**Reference** 21/3025/MFUL

**Location** Land West Of Prestaller Farm Beavor Lane  
Axminster

**Proposal** Erection of 29 dwellings to include highways,  
drainage, landscaping and ancillary incidental  
works.

<b>Committee Date: 25.02.2025</b>
<b>Axminster (Axminster)</b>	<b>21/3025/MFUL</b>	<b>Target Date: 28.02.2025</b>
<b>Applicant:</b>	<b>Neal Summerfield Homes</b>	
<b>Location:</b>	<b>Land West Of Prestaller Farm Beavor Lane</b>	
<b>Proposal:</b>	<b>Erection of 29 dwellings to include highways, drainage, landscaping and ancillary incidental works.</b>

*Figure 1 - Alternative access arrangement for plots 27-30 from the south*

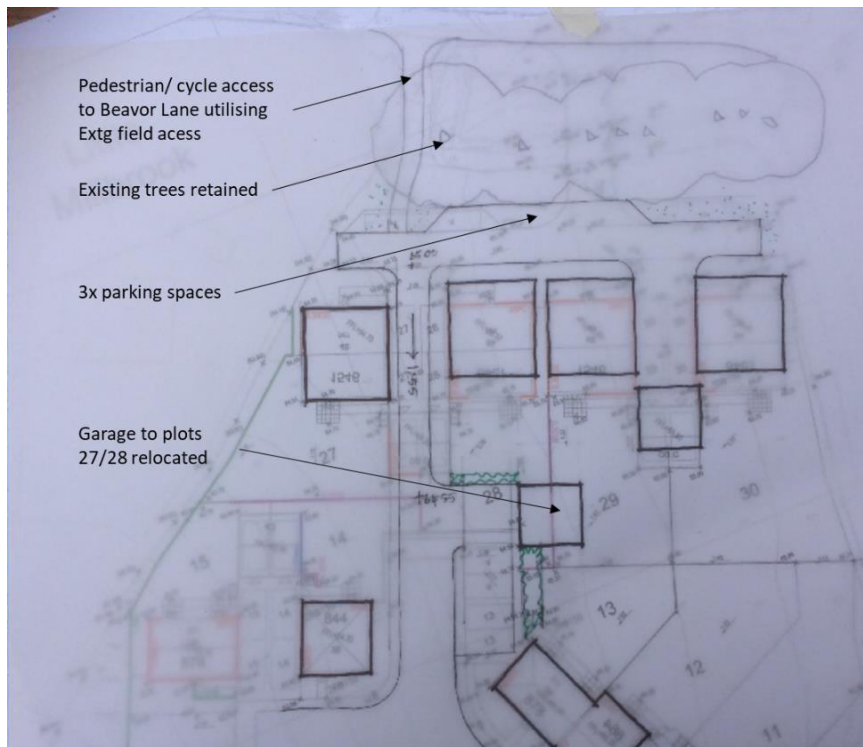
The proposal to create a new vehicular access from Beavor Lane to serve plots 27-30 will entail the loss of existing mature trees to the frontage with Beavor Lane and will increase vehicular traffic along it. Beavor Lane is a narrow, historic lane which is also a public bridleway. The loss of trees and increase in vehicular traffic will have an adverse impact on the character of the lane. Increase in vehicular use could also affect safety of bridleway users. The need for a vehicular access from Beavor Lane seems unnecessary as this could be provided by extending the main site access road from Three Acre Close northwards and providing only a cycle/ pedestrian link onto Beavor Lane via the existing field access in the northwest corner. The sketch overlays (figures 1 and 2) below show how this could be achieved by relocating the garage to plots 27/28 and extending the access road northwards at a gradient of 1:55.

**Image 5.** Location of trees adjacent to the proposed attenuation basin marked in blue

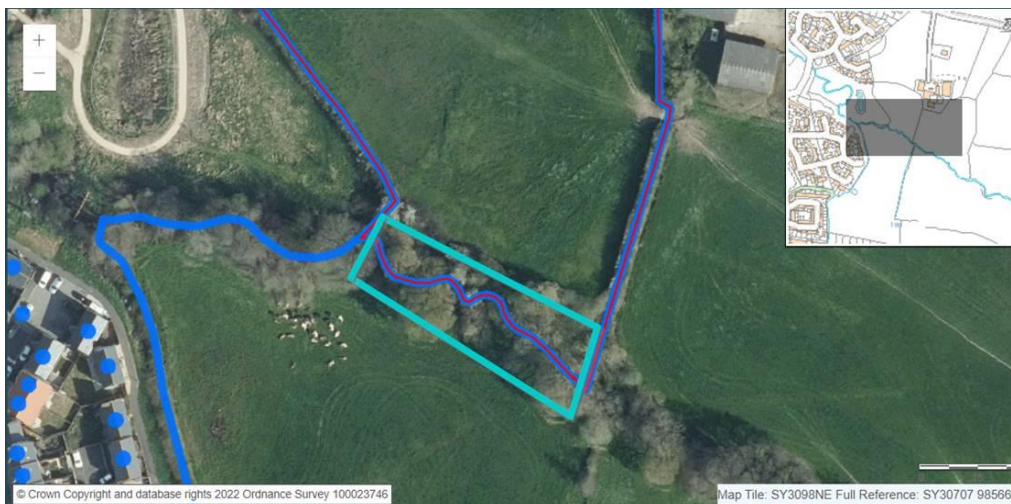
There is a lineal riparian wooded strip of trees, growing along / adjacent to the sites southern boundary (Image 5) and stream. These trees are not included within the site's existing arboricultural survey. The proposed attenuation basin may impact on the Root Protection Area of these trees. Prior to any planning approval these trees will need to be surveyed in accordance with BS5837:2012 and the finding of which added to the arboricultural report, AMS and TPP. The extent of their RPA may impact on the design and layout of the adjacent attenuation basin.

**Image 6.** Extract from the TPP with the entire hedgerow marked in red hatching. According to the adjacent key, this whole hedgerow is to be removed.

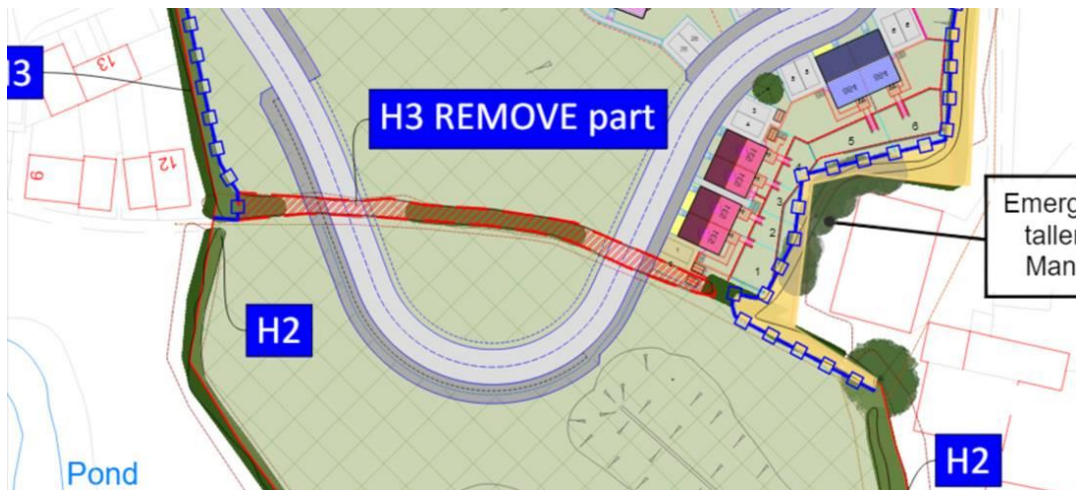
- a) Can the red hatching on the TPP be updated to show only the two sections of hedgerow to be removed. This could be made more explicit by including the dimensions of the retained and removed sections of hedgerow. There is also no tree protection fencing show around the retained section of hedgerow.

**Image 7.** Suggest extension to Tree Protection Fencing marked in blue.

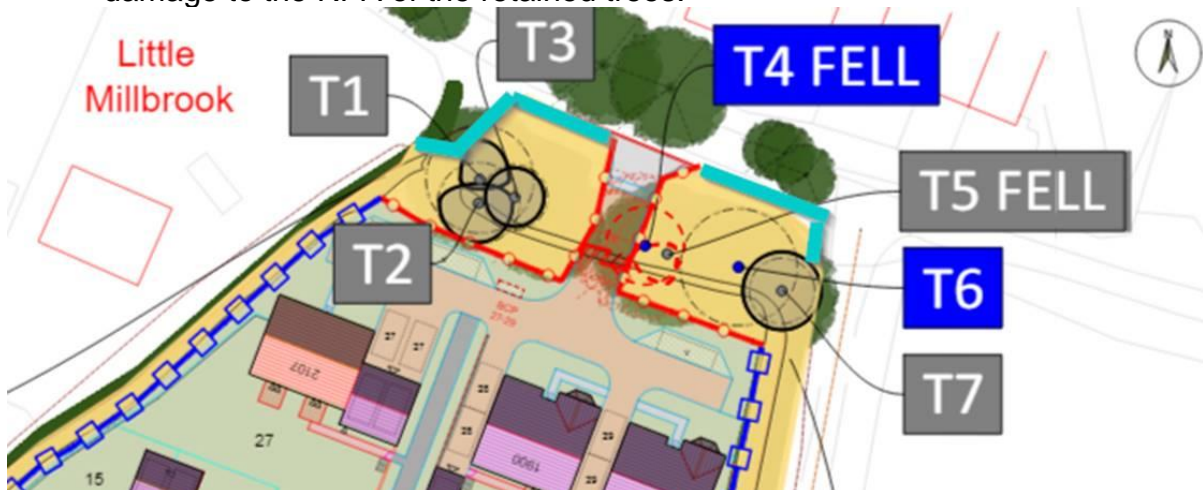
- b) Can the tree protection fencing be extended to include the grass verges on the site's northern boundary. This will avoid them becoming martials drop-off point, or a contractors parking area, causing compaction of the ground and damage to the RPA of the retained trees.
